STAFF RECOMMENDATION
1826 Wildwood Avenue (1817 Rosewood Avenue)
February 20, 2019

Application: New construction-infill
District: Belmont-Hillsboro Neighborhood Conservation Zoning Overlay
Council District: 18
Map and Parcel Number: 11704013200
Applicant: Preston Quirk, Quirk Designs
Project Lead: Melissa Sajid, Melissa.sajid@nashville.gov

Description of Project: The applicant proposes to construct a new single-family home on the rear of the lot, facing Rosewood Avenue.

Figure 4: Height of new construction in relation to historic house at 1826 Wildwood Avenue

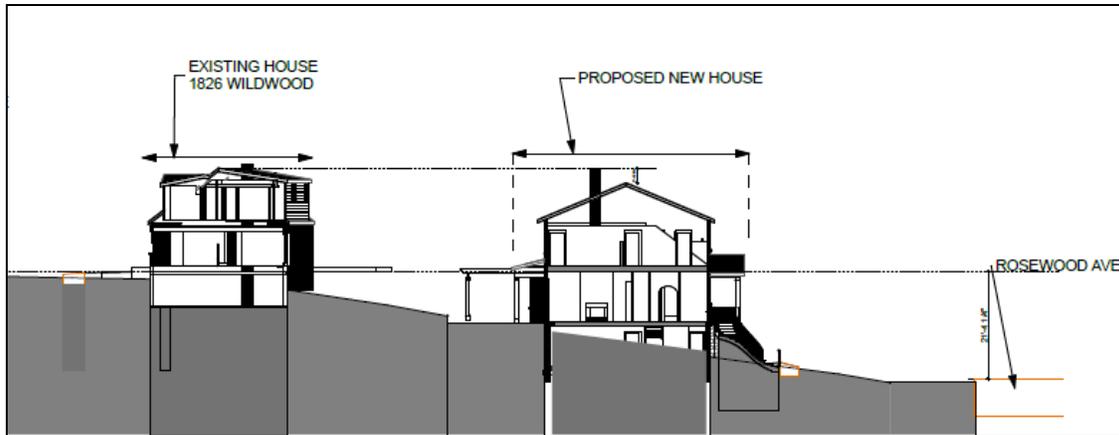
The proposed infill is two (2) stories at the front with an overall height of approximately thirty-five feet (35') including a foundation height of six feet, seven inches (6'-7''), measured from grade. Staff finds that the overall height and foundation height proposed are appropriate in this case as it is comparable to the two existing homes located to the left of the site and will not be taller than the historic house at 1826 Wildwood Avenue when taking into account the change in grade on the site (Figure 4). The tall foundation is necessary due to the drop in grade from back to front. The infill will be forty-nine feet (49') wide at the front, which is also appropriate for the context along Rosewood Avenue.

Staff finds that the new construction's height and scale are appropriate in this case as they are oriented to a street that is outside of the overlay that has no historic context and will have no impact on the historic house oriented to Wildwood Avenue given the significant change in grade across the site. For these reasons, staff finds that the project meets sections II.B.1.a. and b.

SITE PLAN

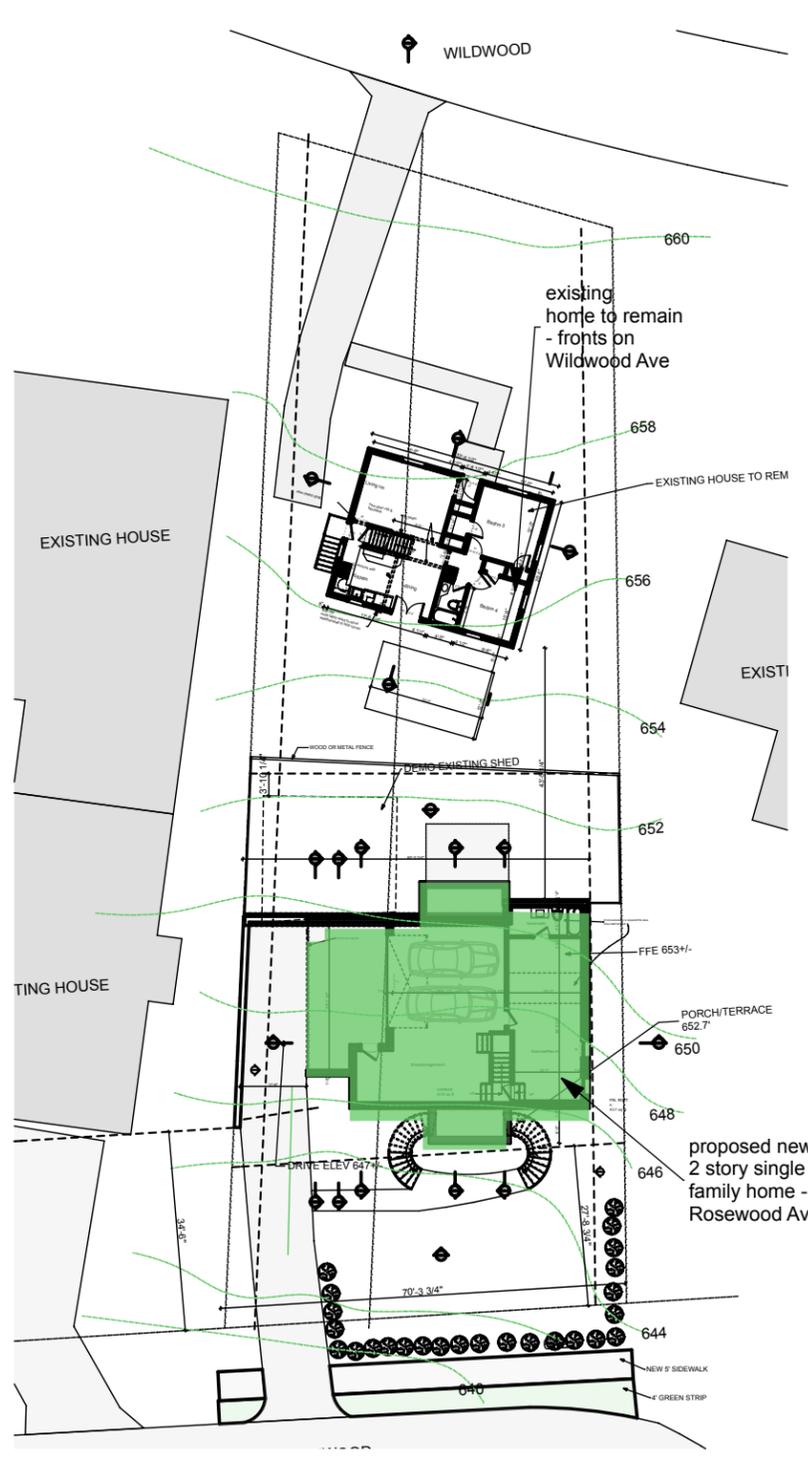
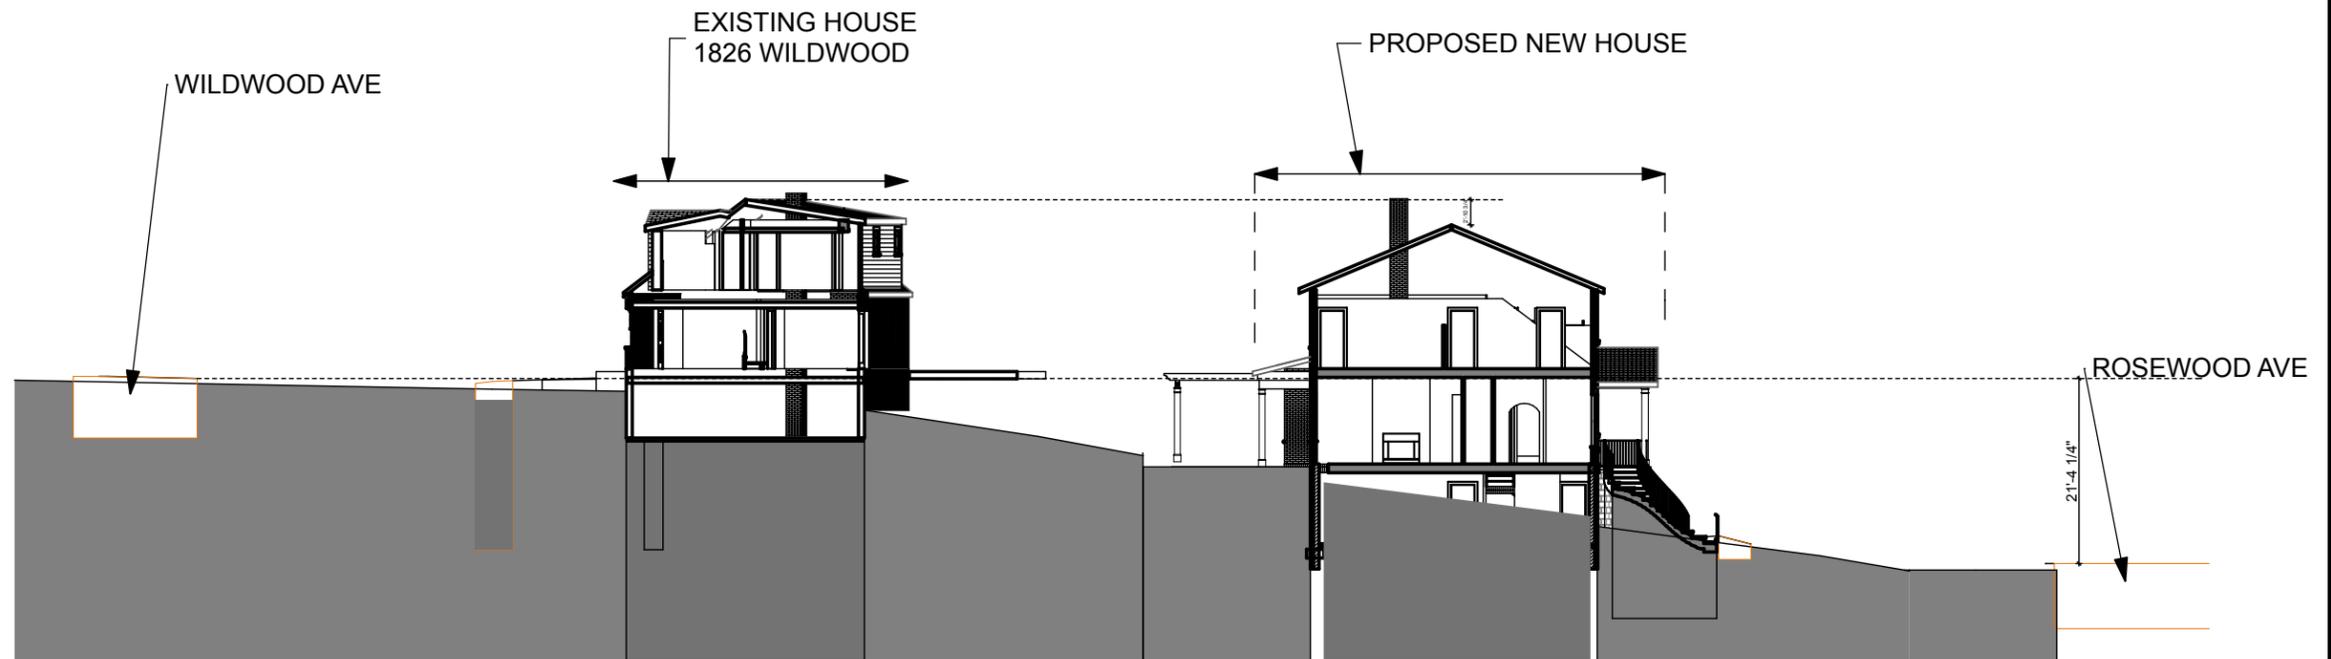
Setbacks: The new construction meets all base zoning setbacks. The side setbacks will be five feet (5') on the right side and eleven feet (11') on the left side. At twenty-seven feet, eight inches (27'-8''), the front setback will be consistent with the house located to the left of the site. The project meets Section II.B.1.c.

1. The finished floor height shall be consistent with the finished floor heights of the adjacent historic houses, to be verified by MHZC staff in the field;
2. The front setback should be consistent with the building to the left side, to be verified by MHZC staff in the field;
3. Staff approve the final details, dimensions and materials of roof color, trim, porch floors and steps, rear porch posts, retaining wall, driveway and walkway material, windows, and doors prior to purchase and installation;
4. The HVAC shall be located behind the house or on either side, beyond the mid-point of the house; and
5. Staff approve the masonry color, dimensions and texture.

DATE: 2/6/19
REVISION
PROJECT NO: 16-072
COPYRIGHT 2/6/19 QUIRK DESIGNS
ELEVATIONS, F, R

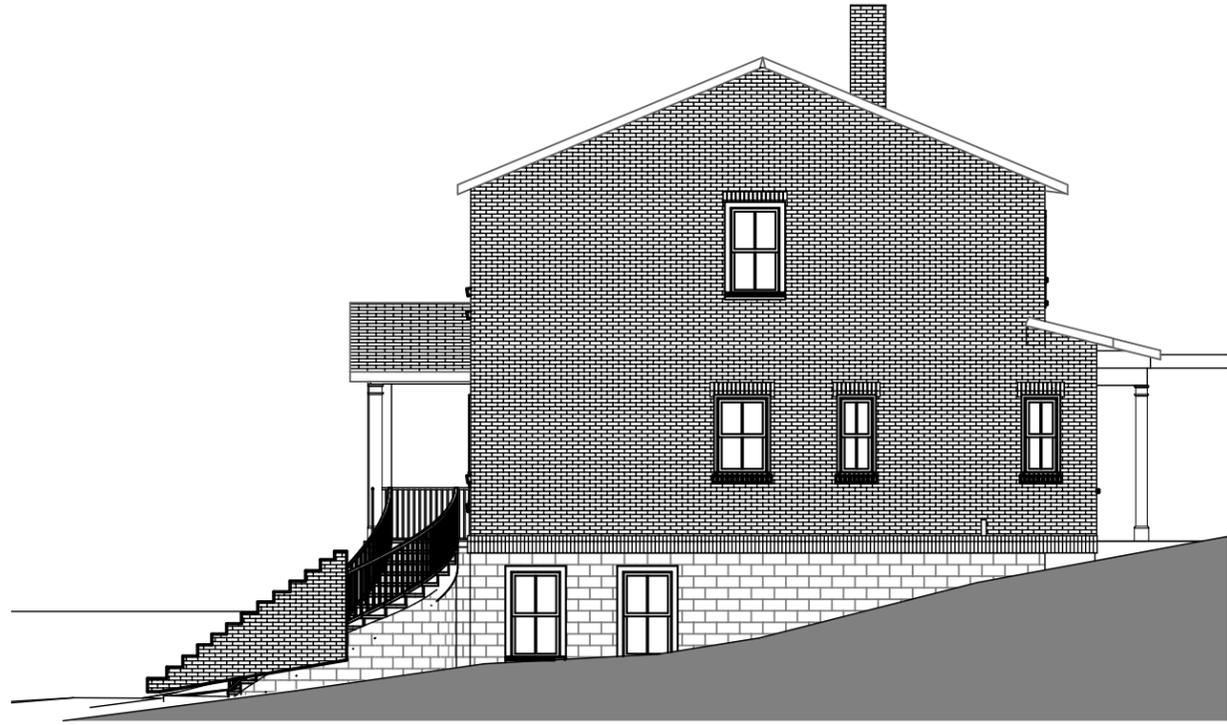
With the condition that staff review and approve the roof color, trim, porch floors and steps, rear porch posts, retaining wall, driveway and walkway material, windows, and doors as well as the masonry color, dimensions, and texture, staff finds that the project meets Section II.B.1.d

Proportion and Rhythm of Openings: All of the windows on the new construction are generally twice as tall as they are wide, thereby meeting the historic proportions of openings. There are no large expanses of wall space without a window or door opening. Staff finds the project's proportion and rhythm of openings to meet Section II.B.1.g.

ROOF PLAN

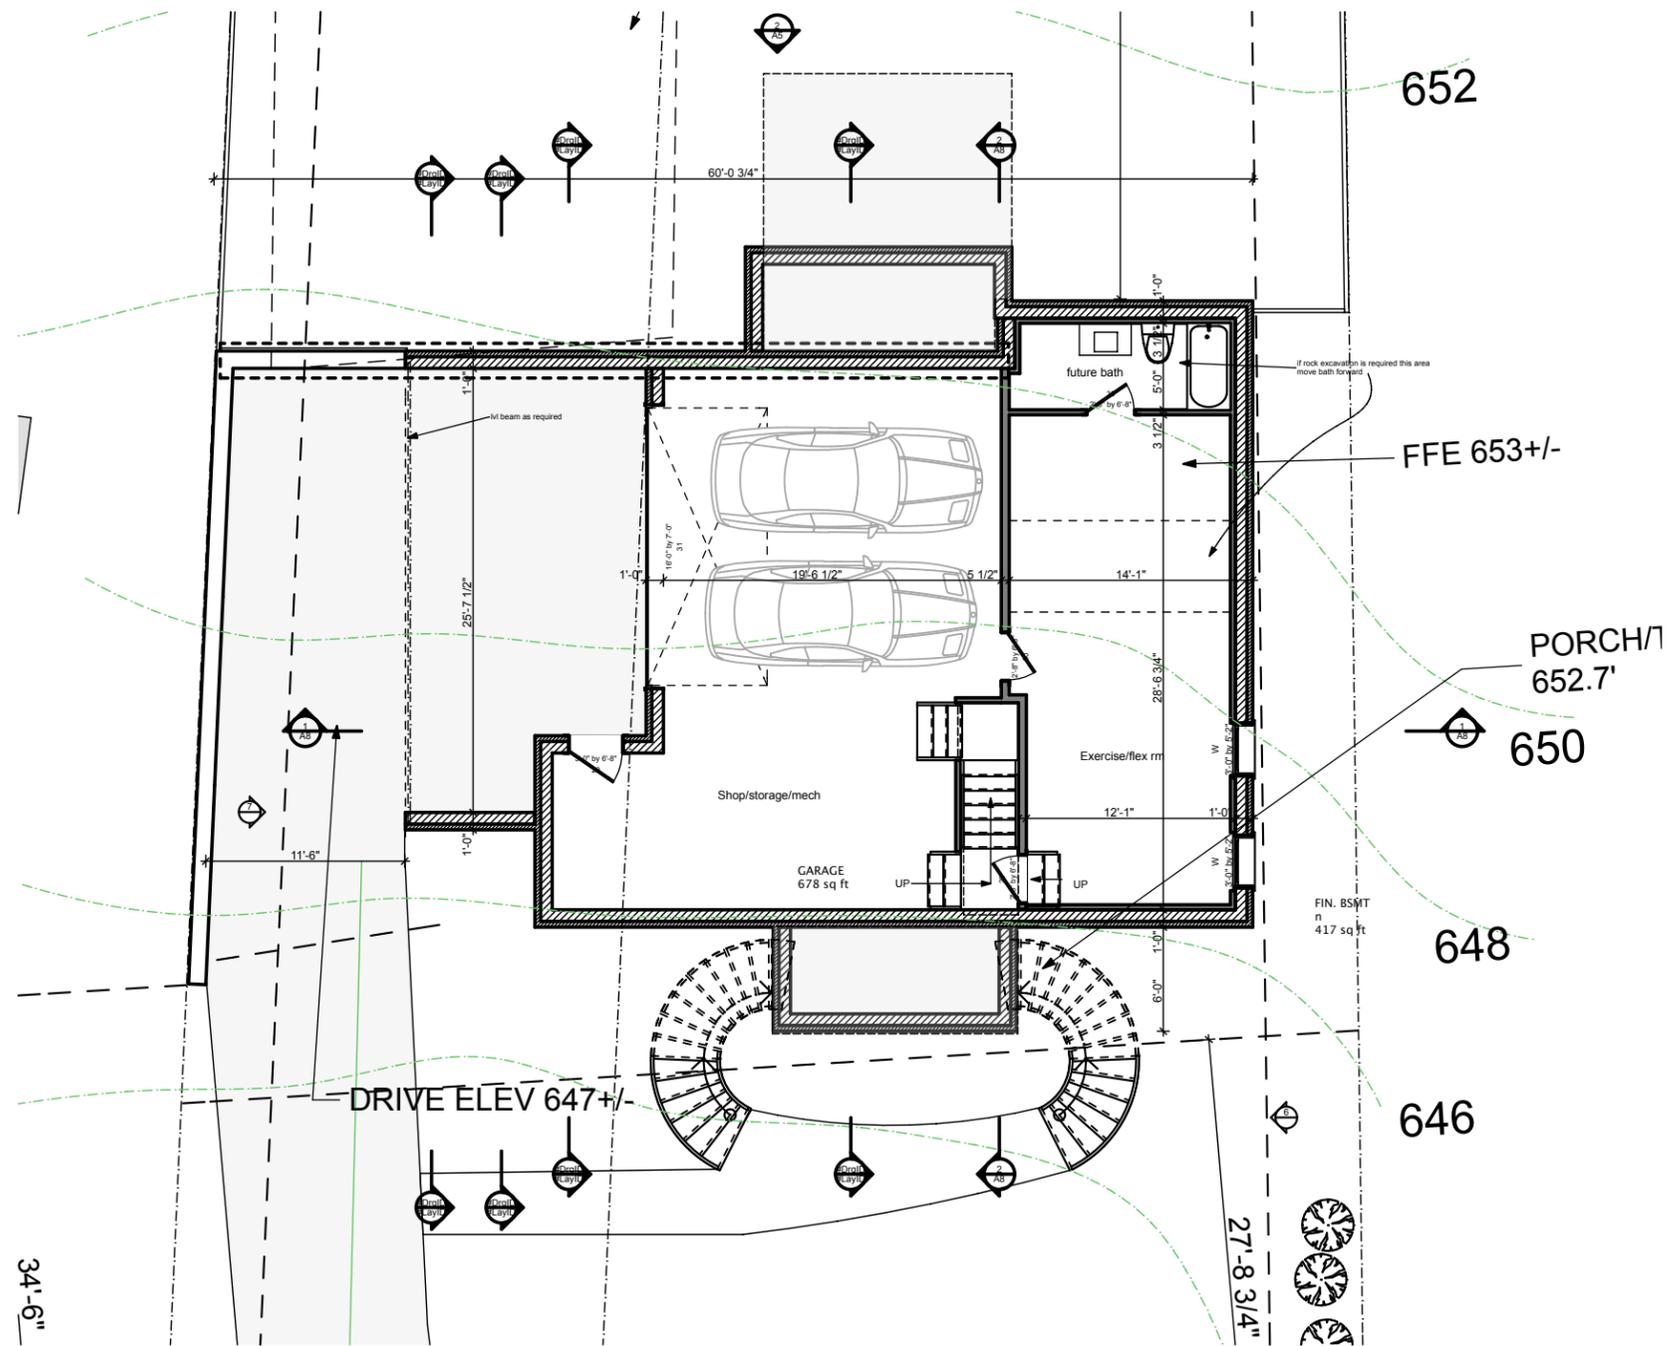
Roof form: The roof will be side-gabled with 5:12 and 9:12 pitches, and the front porch roof will be a front gable with a 6:12 pitch. Staff finds that the roof form and pitches are compatible with the surrounding context on Rosewood Avenue and meet Section II.B.1.e.
